Agilent 35670A Dynamic Signal Analyzer

**Supplement to Installation,
Service and Operator's Guide**

The purpose of this supplement is to describe changes to the display of the Agilent 35670A. These changes apply only to instruments with a serial number higher than MY42506200 made after December 2002.

Figure 1 Rear panel

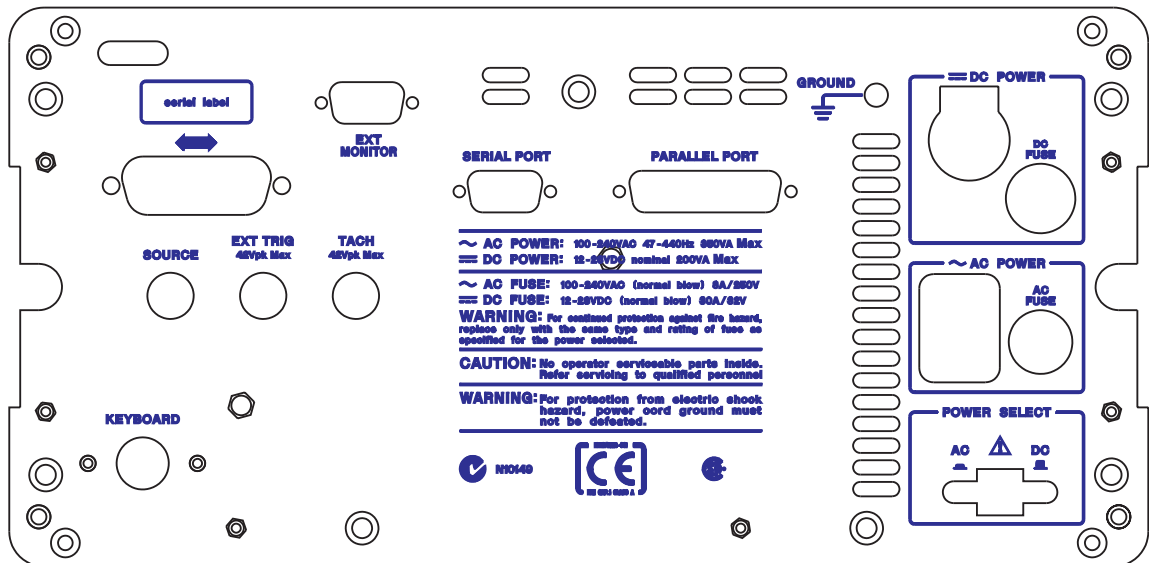
The illustration below shows the new rear panel. The only change is in the location of the external monitor connection. This is the only place in this supplement that shows the new rear panel unless a detailed illustration is required.

Figure 2 Rear panel showing external monitor connector

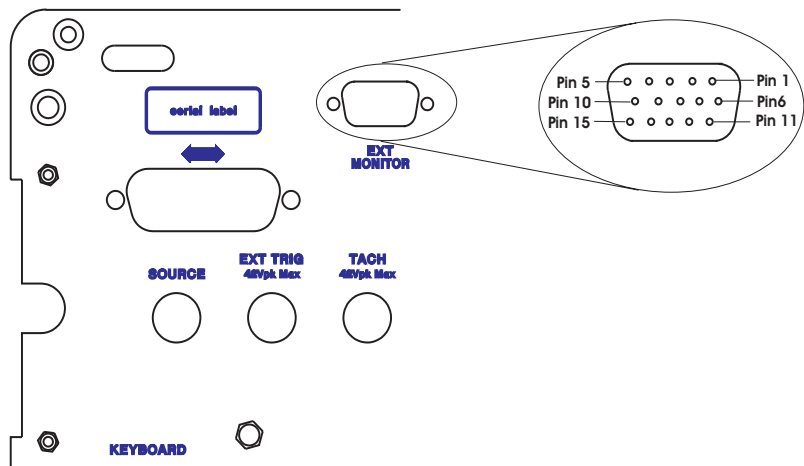
The Agilent 35670A has incorporated a standard VGA monitor output and is now compatible with most monitors.

The External Monitor is a standard 15-pin miniature connector that can interface with an external monitor. The monitor must be compatible with the 49.74 kHz line rate, 61.6 Hz frame rate, analog RGB signals, and TTL sync signals provided by the Agilent 35670A.

- 1 Set the analyzer's power switch to on (|).
- 2 Set the monitor's power switch to on.
- 3 Connect the external monitor's input cable to the analyzer's rear panel EXT MONITOR connector.
- 4 Press the following keys to enable external display mode:

Figure 4 Rear panel showing external monitor connector

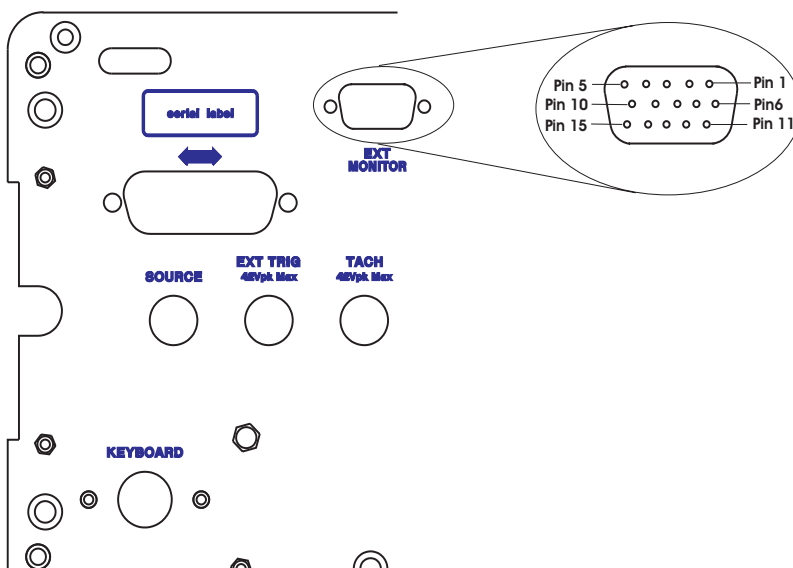
The External Monitor is a standard 15-pin miniature connector that can interface with an external monitor. The monitor must be compatible with the 49.74 kHz line rate, 61.6 Hz frame rate, analog RGB signals, and TTL sync signals provided by the Agilent 35670A.

- 1 Set the analyzer's power switch to on (|).
- 2 Set the monitor's power switch to on.
- 3 Connect the external monitor's input cable to the analyzer's rear panel EXT MONITOR connector.
- 4 Press the following keys to enable external display mode:

Figure 5 A17 CPU board test point locator

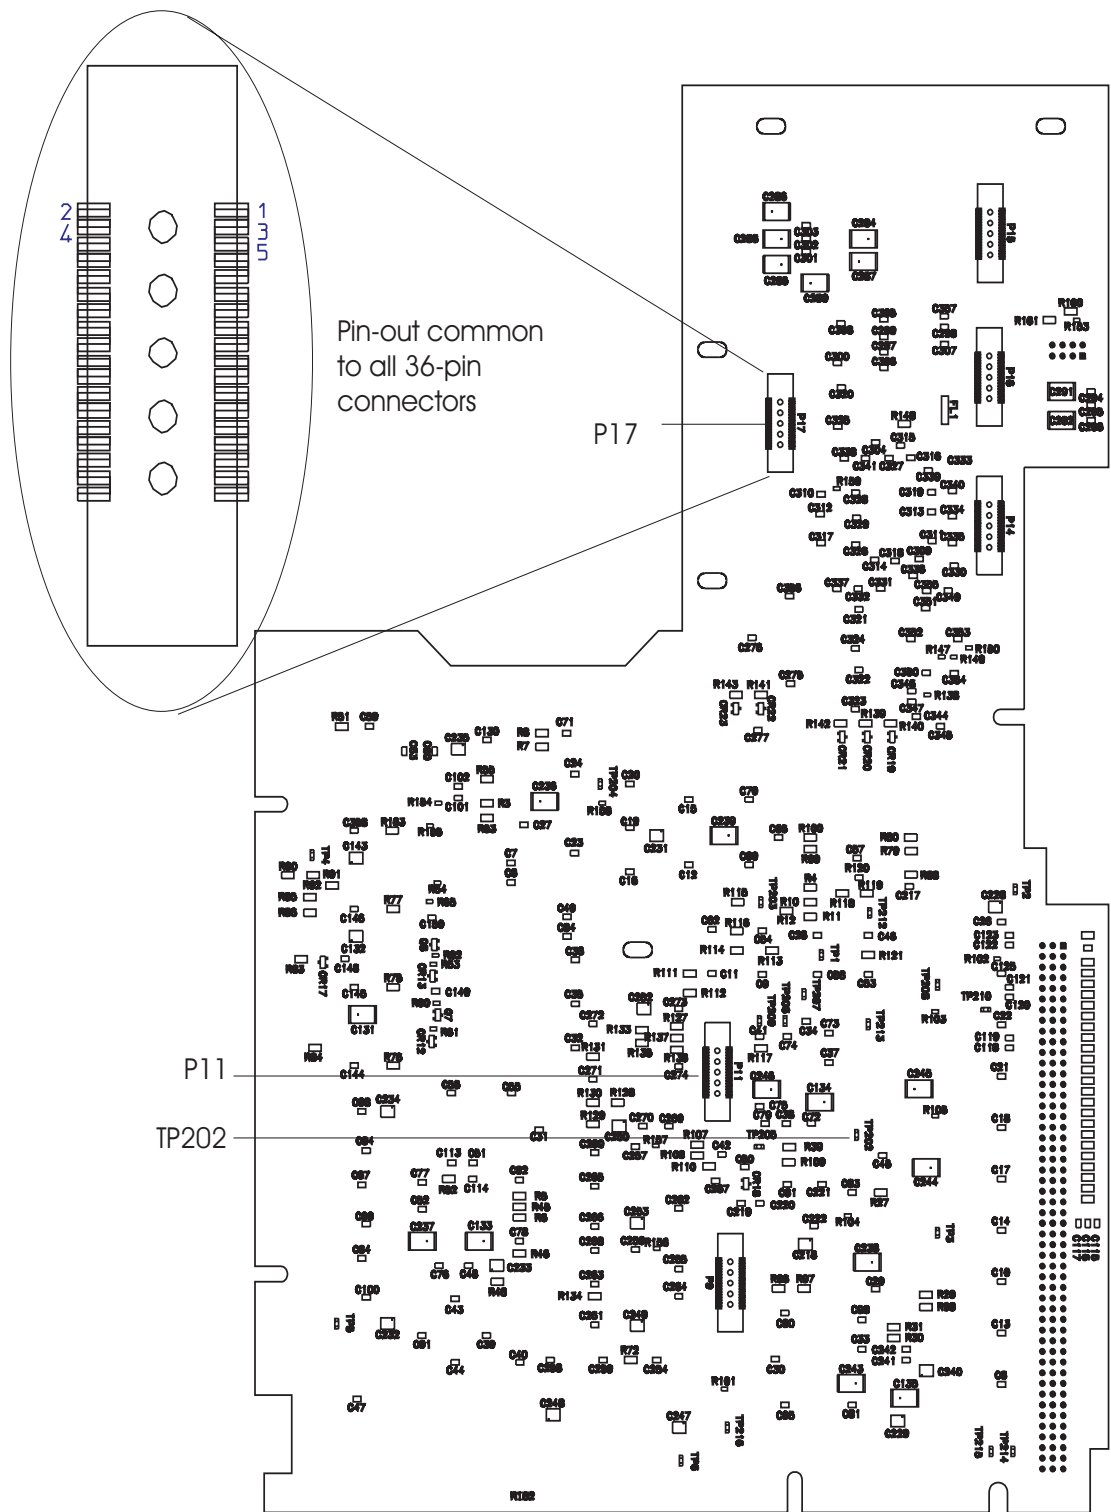
New illustrations for component locators show new test points and new connector locations:

Replace Step 7: Check signals required for power up.

- Using a logic probe, check the following signals.

Figure 6 A17 CPU board connector locator, component side

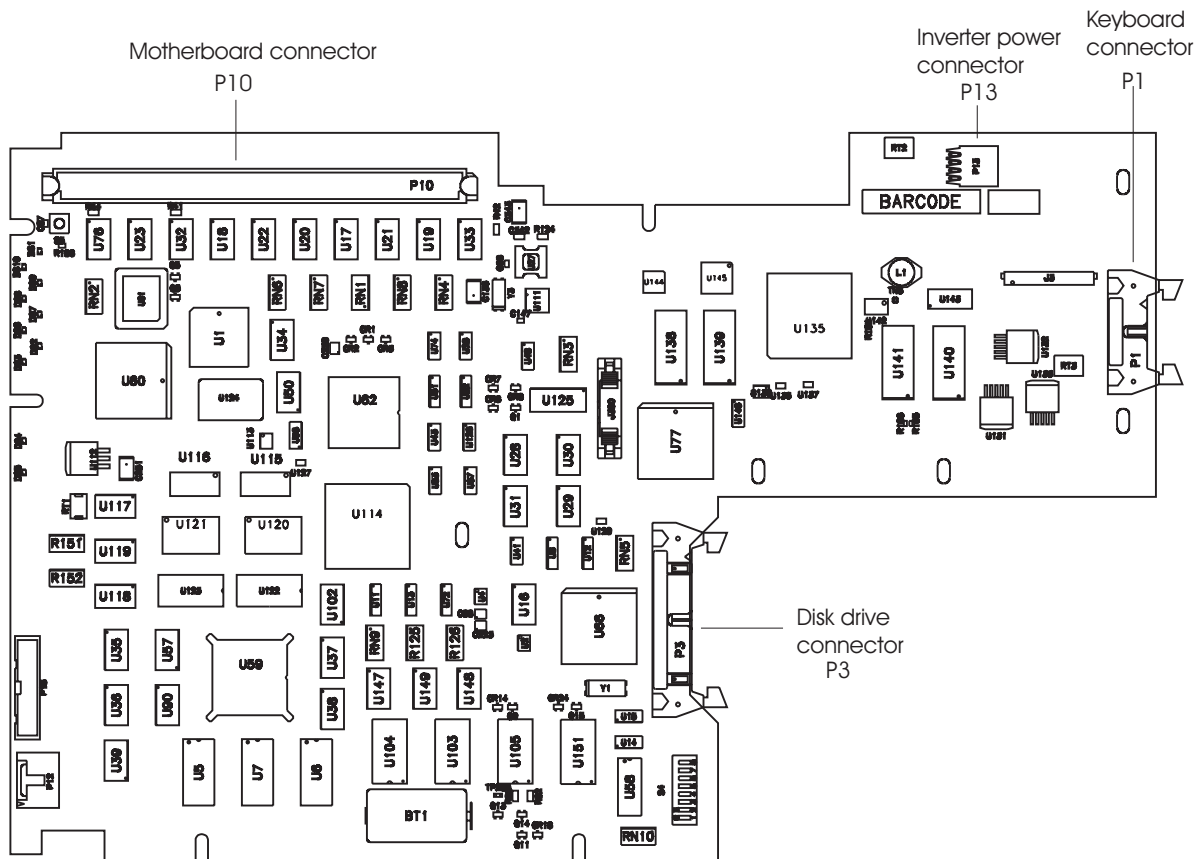
The illustration for component locator shows new connector locations.

Step 5: Replace the bullet concerning reconnecting assemblies:

- Reconnect one assembly at a time in the following order:
 - 1 A17 CPU (A17 P10 to A99 J7)
 - 2 A102 Power Inverter (cable to A17 P13)
 - 3 A11 Keyboard Controller (Cable to A17 P1)
 - 4 A100 Disk Drive (cable to A17 P3)

Figure 7 A17 CPU board connector locator, component side

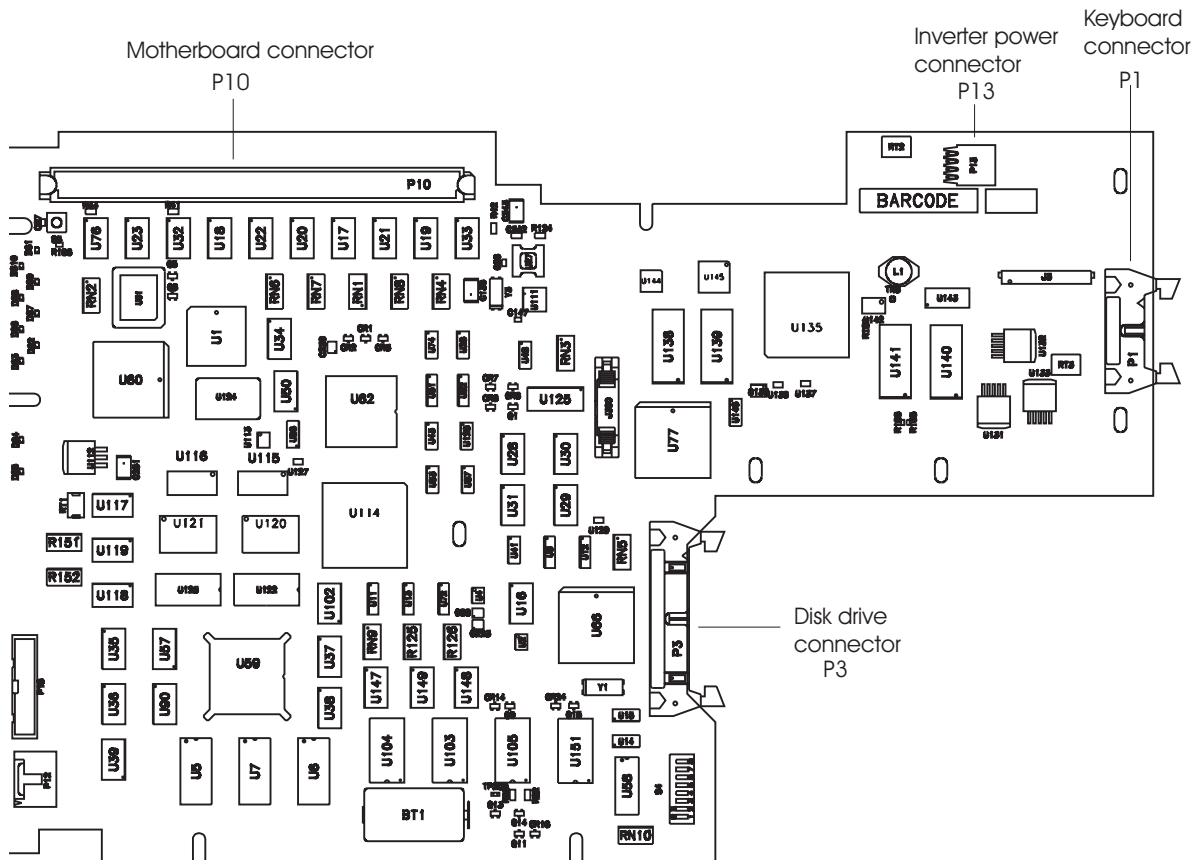
Step2: Illustration for component locator shows new connector locations

Step 1: Disregard references to Memory Assembly and incorporate the related information into A17 CPU.

Figure 8 A17 CPU board connector locator, circuit side

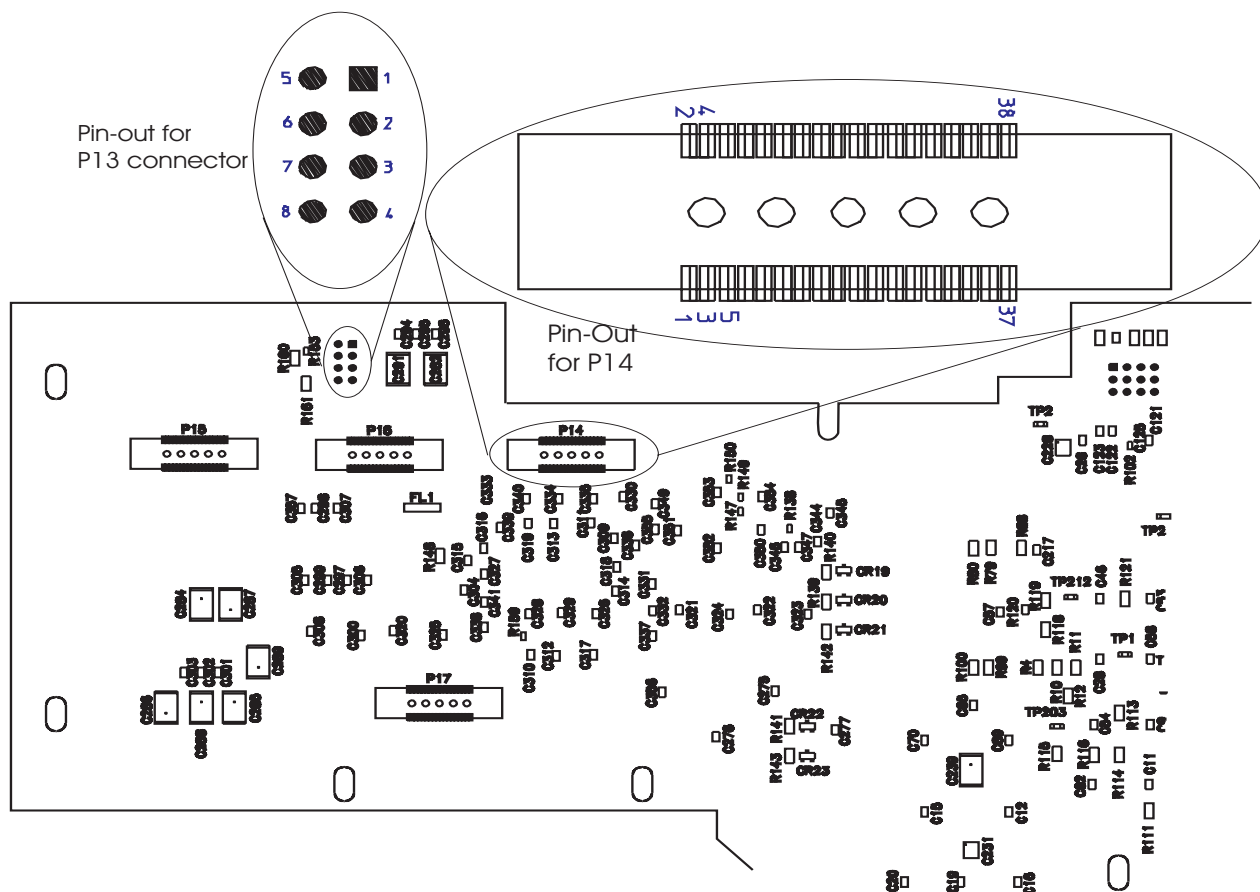
Replace entire section

Use this test to isolate display failures to the A101 Display assembly, A102 assembly, or the A17 CPU assembly

- ✓ Step 1. Check the power inverter assembly.
 - Set the power switch to off (O).
 - Remove the cable connected to P13 on the A17 assembly.
 - Set the power switch to on (|)
 - Measure voltage at P13 pin 1 on A17 assembly.
 - If voltage is not +5Vdc the A17 board may be faulty.
 - Set the power switch to off (O).
 - Reconnect the cable to P13.
 - Set the power switch to on (|).
 - Measure voltage at A17 P13 pin 1.
 - If voltage is not +5Vdc the power inverter assembly may be faulty.
 - If display backlight lamps do not light up, one or both of the lamps may be faulty.
 - If lamps are replaced and still do not light up, the power inverter may be faulty.
- ✓ Step 2. Check the CPU signals on the Display assembly.
 - Set the power switch to on (|).
 - Using a logic probe check that the following TTL signals are toggling:

- If the signals are incorrect the A17 board may be faulty.

Figure 9 A17 CPU motherboard (P10) connector pin locations

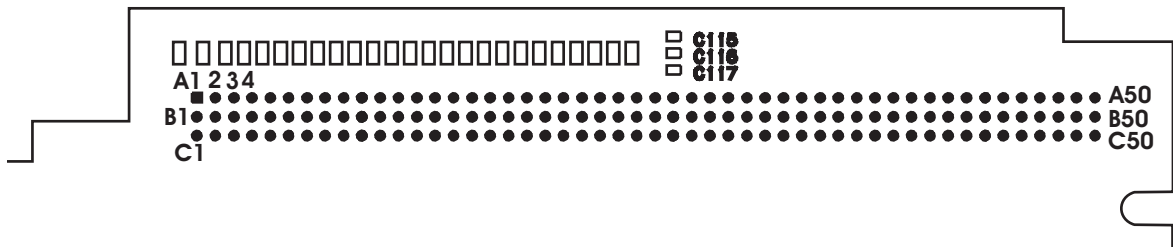
A new illustration above step 2 shows new connector pin-outs:

- ✓ Step 2. Check the serial clock (SCL).
 - Attach a logic probe to A17 P1-15 (SCL) or P10 pin B10.
 - Set the power switch to on (|).
 - Press S5 (reset switch) while monitoring A17 P10 pin B10 (SCL), the power-on LEDs, and the display.

S5 (reset switch) is a normally open momentary switch. A press of the switch, S5, can be simulated by temporarily shorting TP214(RESET INn) to TP215 (DCOM).

Figure 11 A17 CPU motherboard (P10) connector pin locations

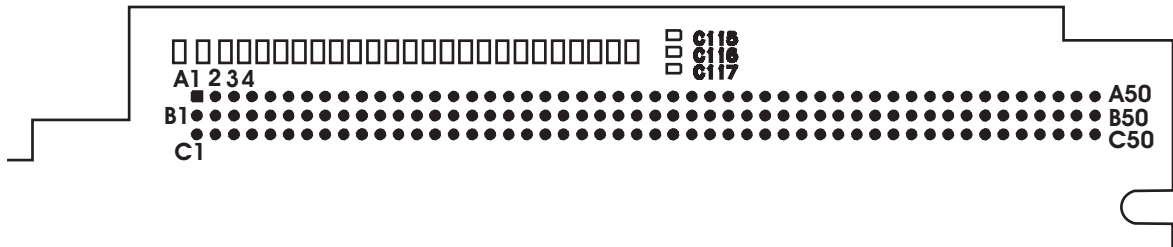
New illustration showing location of motherboard connector pins.

New table:

Figure 12 Battery location

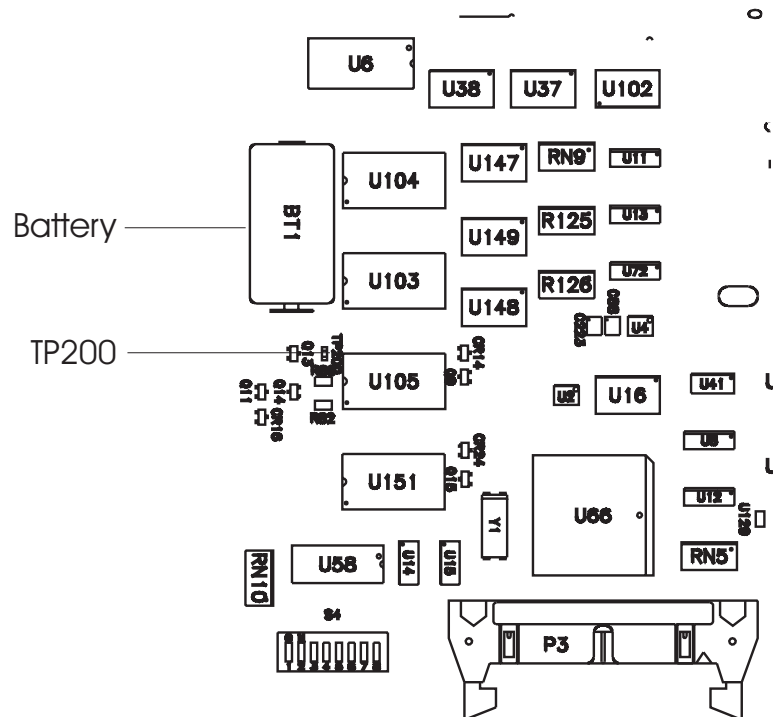
Replace the last five bulleted items:

- If the date is 01-01-01, the battery-backed-up memory is functioning correctly. Enter the current date. Go to page 4-13, "To perform self tests," to continue troubleshooting.
- Set power switch to off (O)
- Check that the voltage at TP200 is 2.6Vdc to 3.1Vdc.
- If the voltage is correct, the memory is probably faulty.
- If the voltage is incorrect, replace the battery BT1.

Figure 13 Location of U111

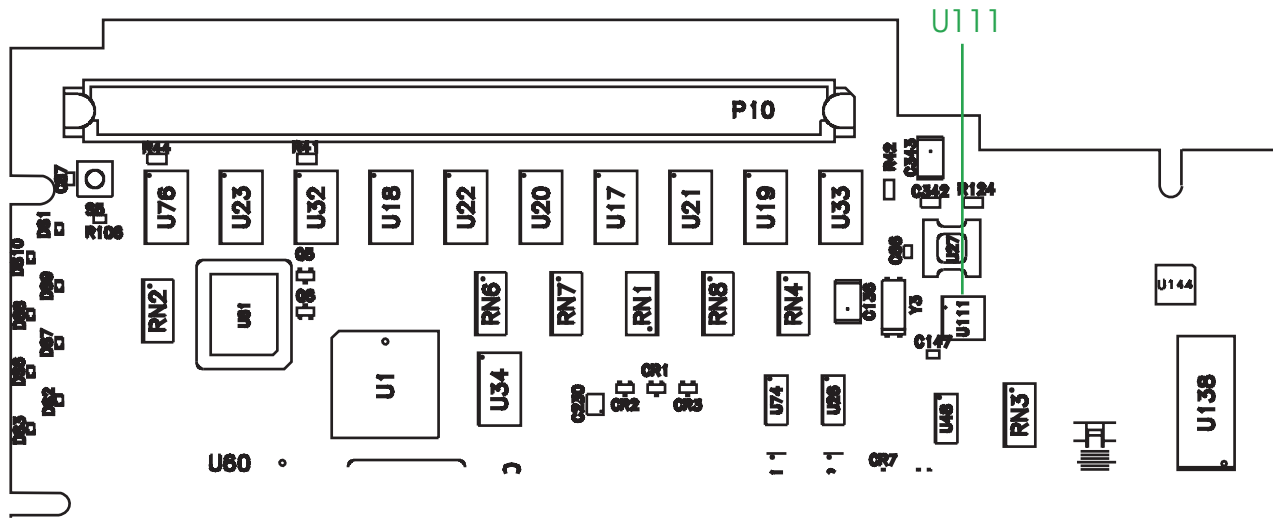
The EEPROM is now U111 on the A17 CPU assembly.

Figure 14 Disconnect the cables from A17

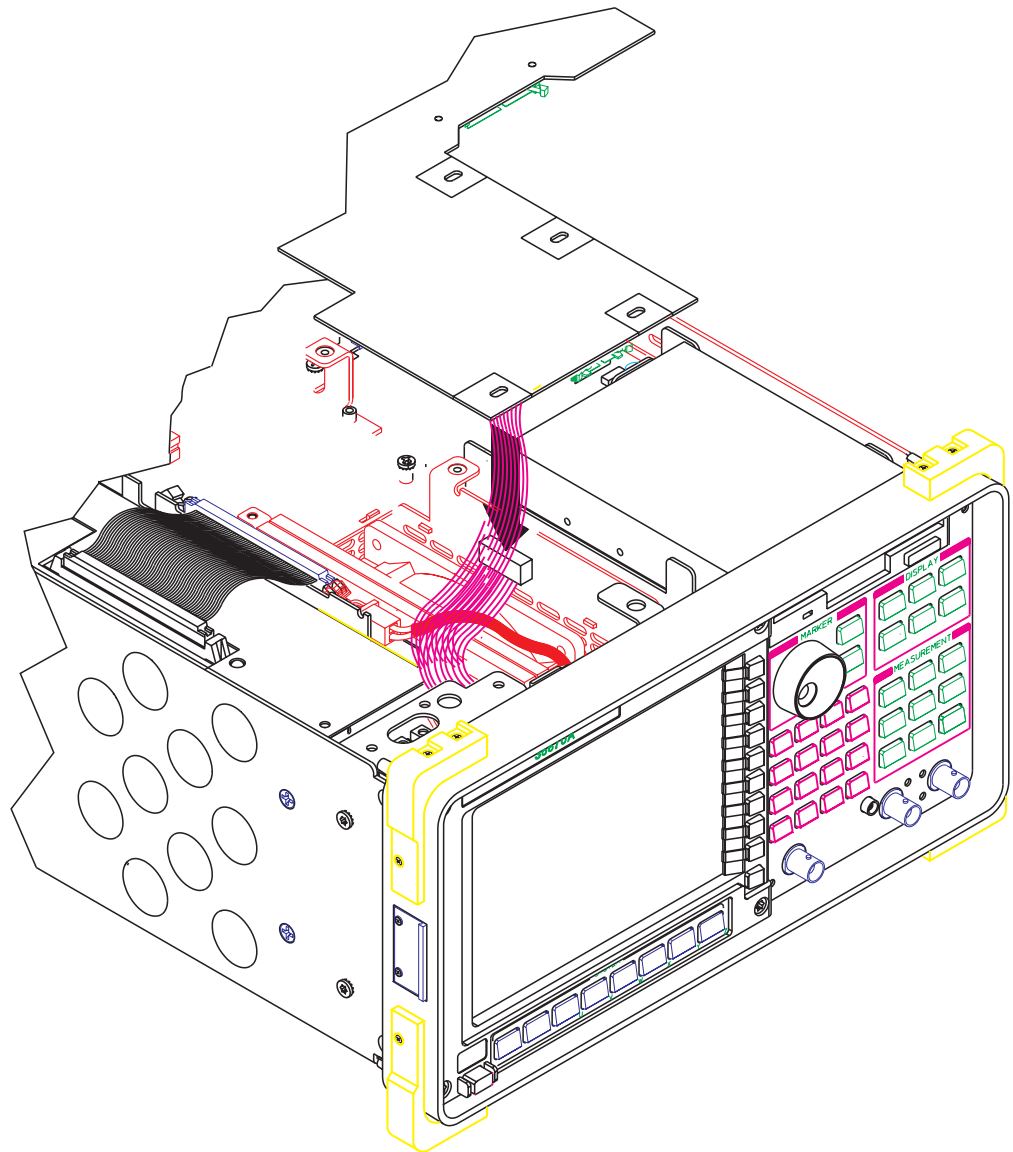
New illustration in step 3 showing an additional cable:

Figure 15 Assemblies

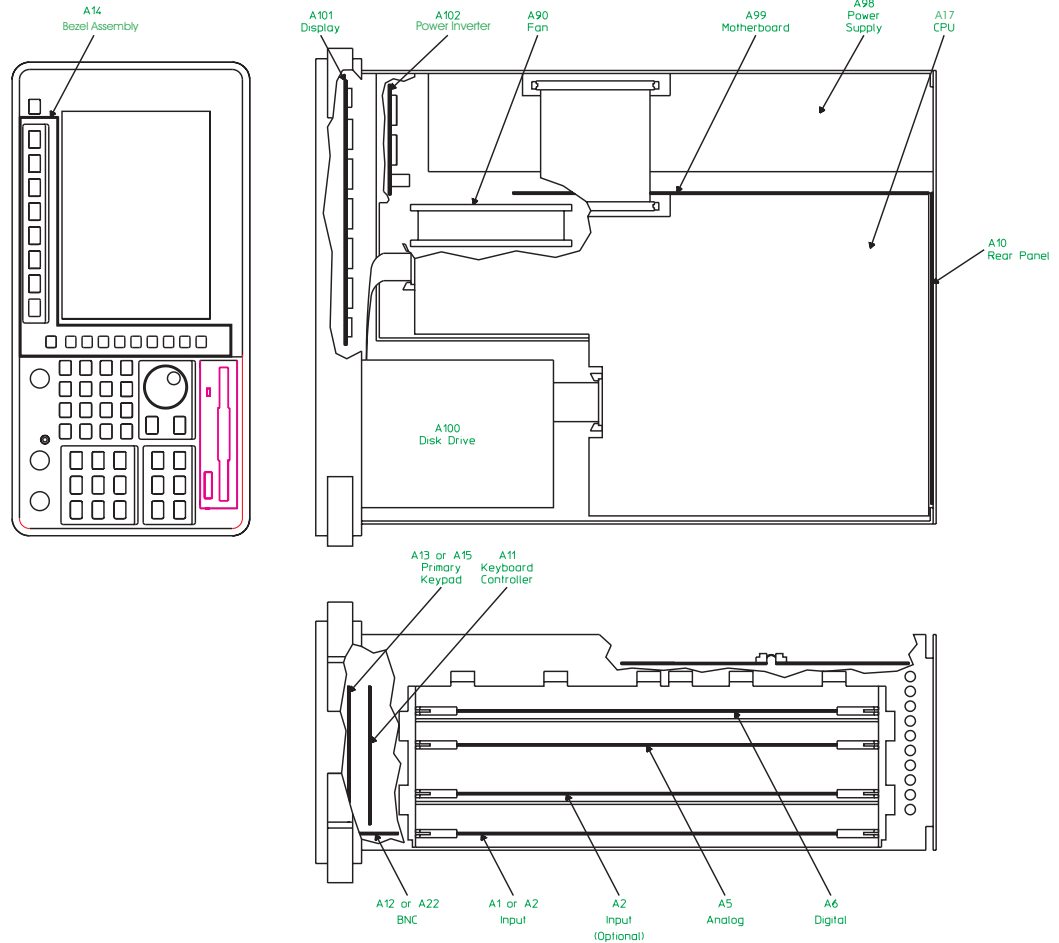
Reference designator A17 replaces A7, A8 and A9. There is also a replacement motherboard, bezel assembly, display assembly and DC-DC converter assembly.
